Index 102-620

Multilane, Divided, Temporary Diversion Connection

COMMENTS AND RESPONSES

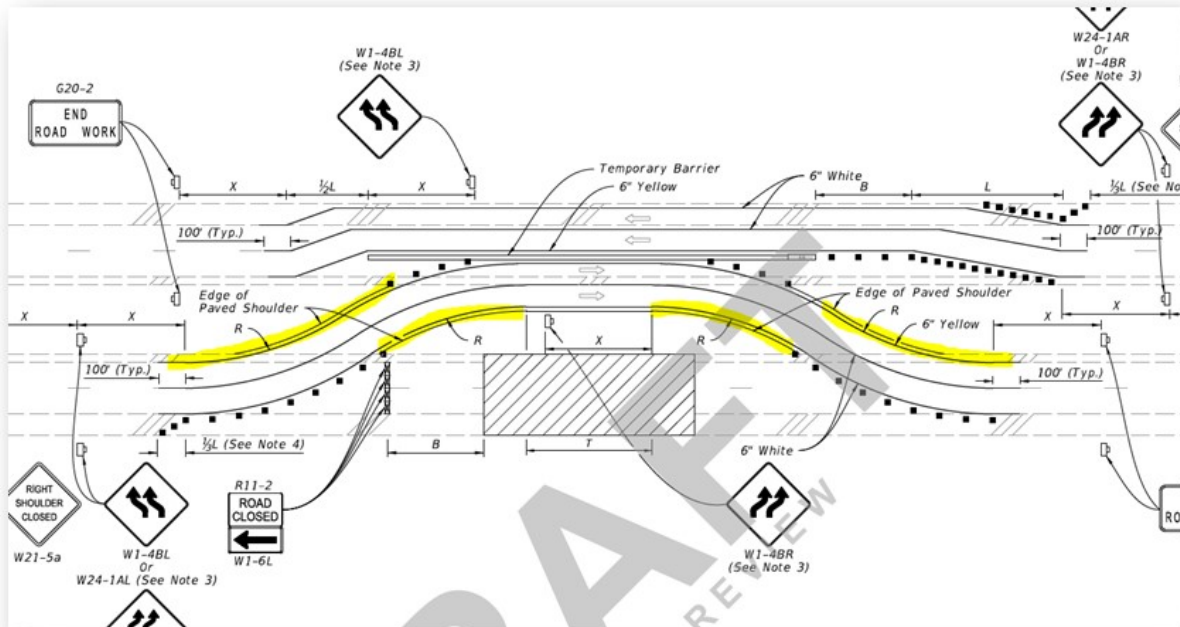
2. Sheet 3: Need Advance warning Arrow board on both directions.

RESPONSE: *Agreed.*

Change Made: *Arrow Board added for both directions of travel.*

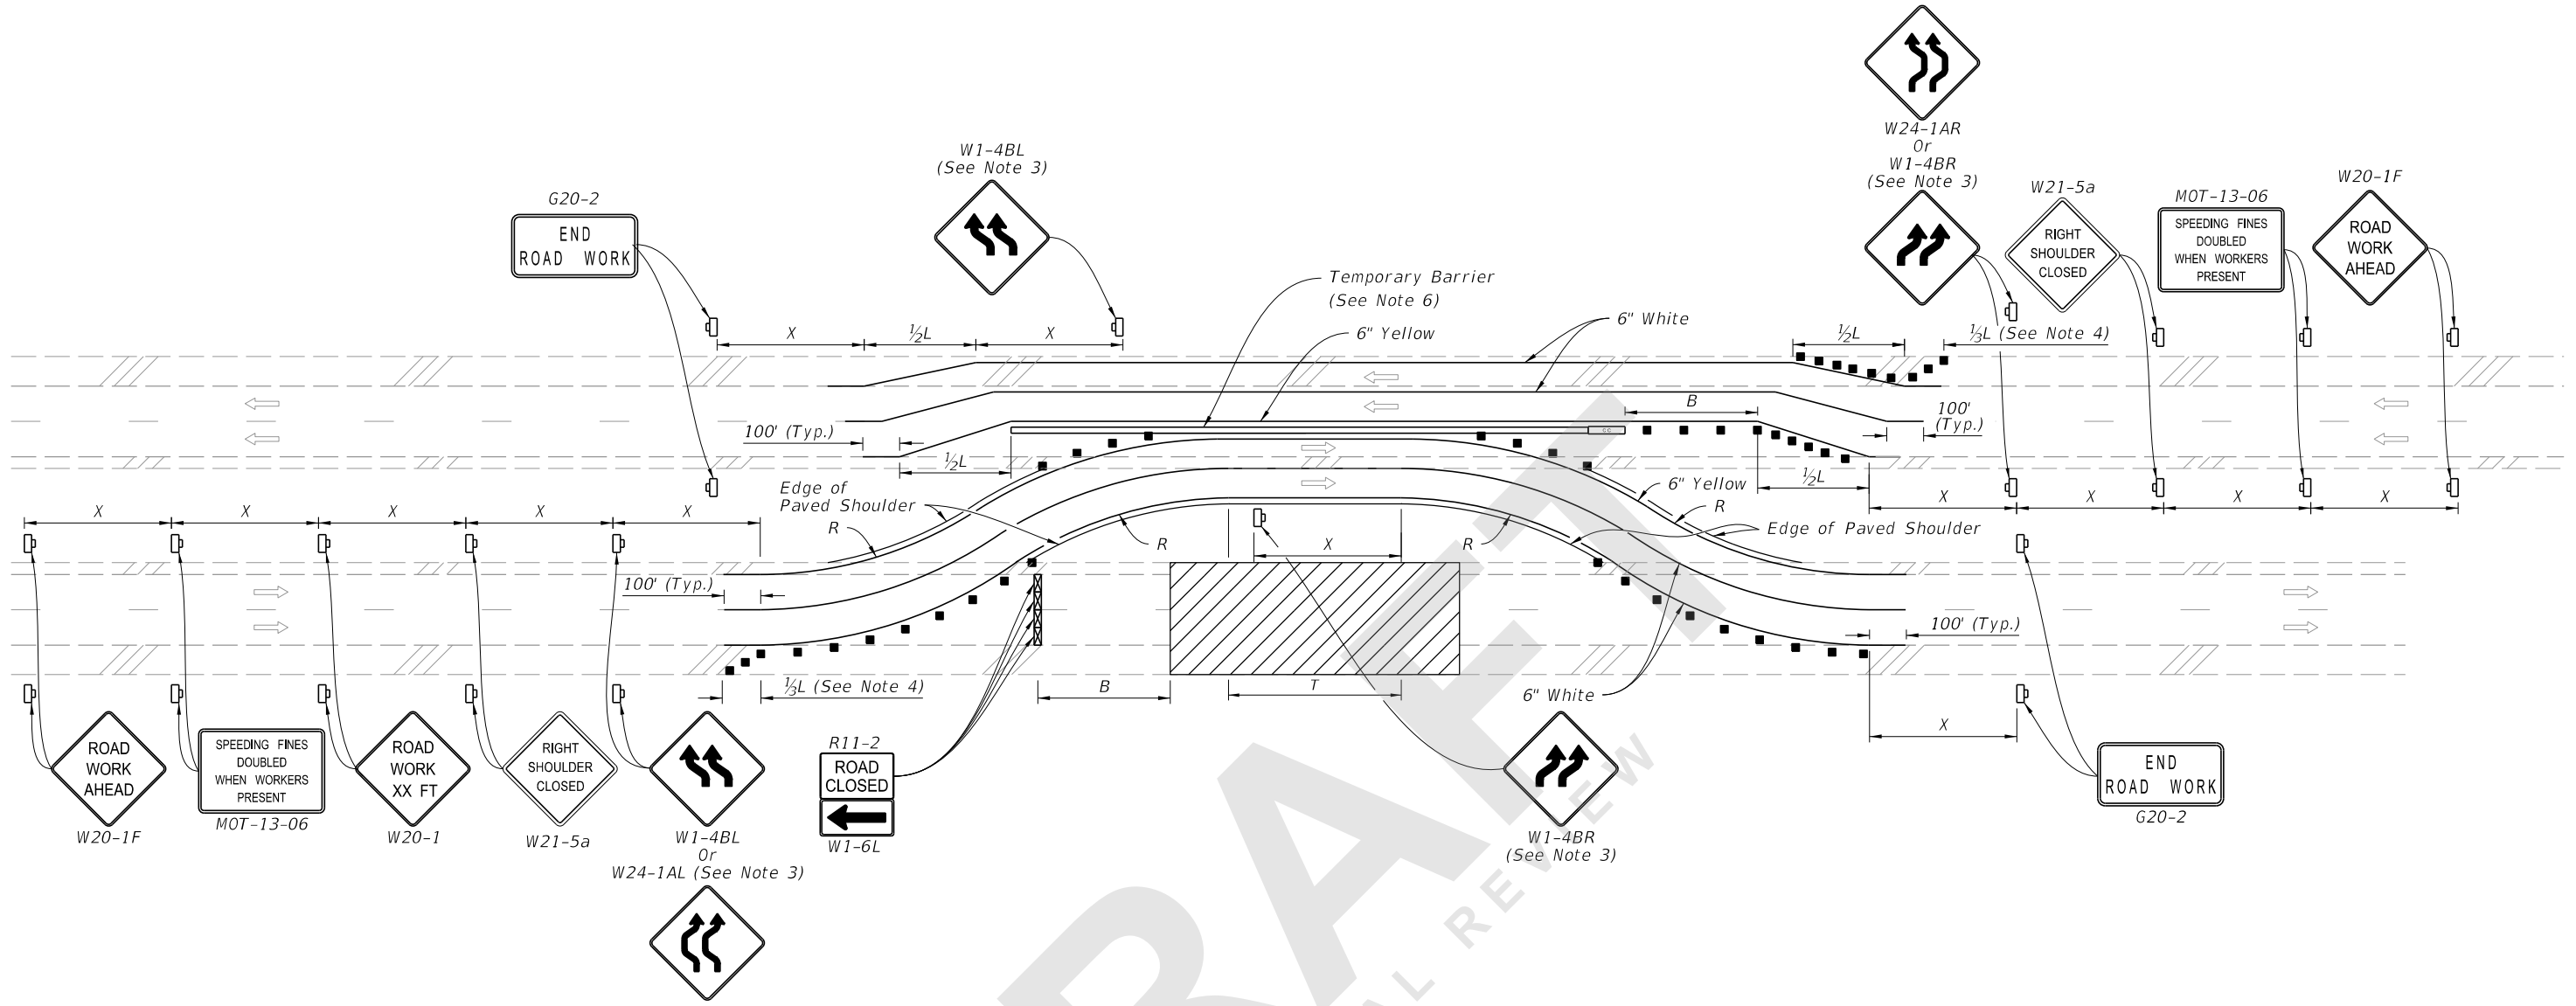
2. Sheet 3: Need callout for temporary lane separator

RESPONSE: *Agreed.*

Change Made: *See Response Above for Sheet 2.*

TEMPORARY DIVERSION FOR DIVIDED ROADWAYS

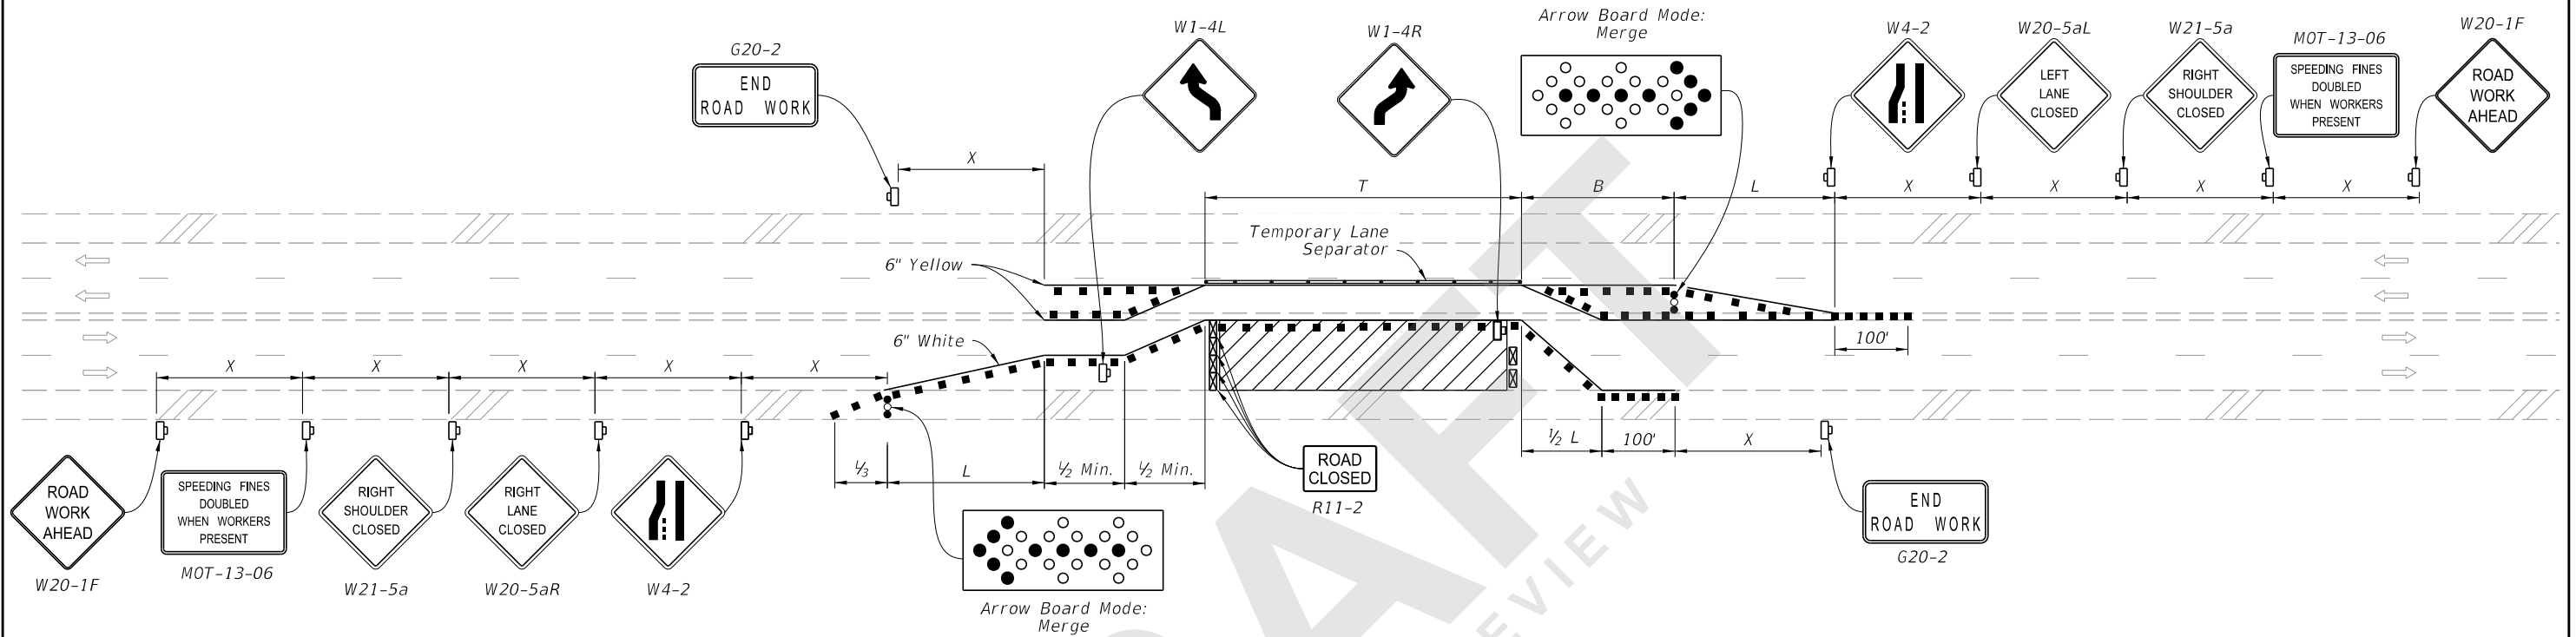
1. 102-620 (1,2/3): Why is the length of the two adjacent lanes at the taper heading to the left not have the same length? Both should be parallel and cover the "L" distance.

2. 102-620 (1,2/3): Why only half of the taper length distance is used for the realignment of the traffic at the left end of the diversion? The vehicles will be driving at the same speed and is not like we are opening a new lane.

-
3. 102-620 (1,2/3): Why are there no channelizing devices or barriers between the traffic and the work area at the tangent section? The work zone area is not protected. The WZ area could be within the clear zone and this index allows not using barriers or devices. Also, not Channelizing Devices are used along the inside edge of the curvature section.

1. Sheets 1 & 2: Need the offset distance from 6" yellow stripe to work area to be notated; Should this be clear zone distance?

1. Sheet 2: Personal Opinion? Figures are the same except for lane separator type. Could these be combined and descriptive notes on which one is to be used in which condition? Or is it preferred to show the difference between low- and high-speed separation configurations?

RESPONSE: *Agreed. The proportionality of the shifts needs to be revised. However, the carryover of the full "L" taper length was in error. This is a shifting taper and should be "1/2 L".*

Change Made: *The details will be updated to correct the proportionality and revised to use a taper length of "1/2 L".*

RESPONSE: *In accordance with the MUTCD, Merging Tapers use the full "L" value, shifting tapers use "1/2 L", and Shoulder Tapers "1/3 L".*

RESPONSE: *The details shown throughout the 102 Series TTC Standard Applications (i.e., Indexes 102-601 thru 102-680) are rudimentary typically applications and do not represent all possible scenarios. Project specific TTC Plans would almost always be needed for projects with diversions. Additionally, the requirements of Specification 102 and Index 102-600 apply to all Indexes in the series. Therefore, if the work area is within the clear zone, channelizing devices or temporary barrier would be required.*

RESPONSE: *The details shown throughout the 102 Series TTC Standard Applications (i.e., Indexes 102-601 thru 102-680) are rudimentary typically applications and do not represent all possible scenarios. Project specific TTC Plans would almost always be needed for projects with diversions. Additionally, the requirements of Specification 102 and Index 102-600 apply to all Indexes in the series. Therefore, if the work area is within the clear zone, channelizing devices or temporary barrier would be required.*

RESPONSE: Agreed. Consideration will be giving to consolidating the details.

Change Made: Details consolidated onto Sheet 1
